CITY OF TULARE PLANNING COMMISSION STAFF REPORT

September 10, 2018

CONDITIONAL USE PERMIT NO. 2018-18

PROJECT: Site Plan Review Application No.: 1844 Masjid Center

SHEET SPR, IBG

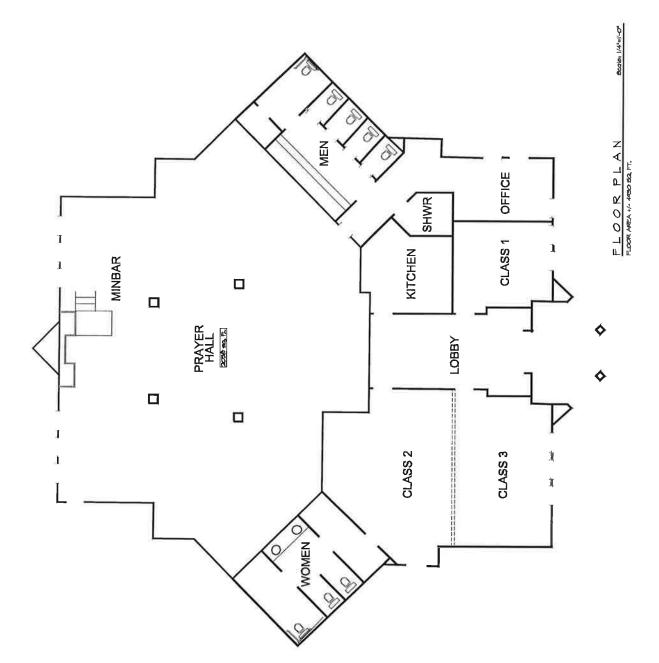
Inadequate number of Trash/Recycling containers to provide sufficient service. See comments attached.
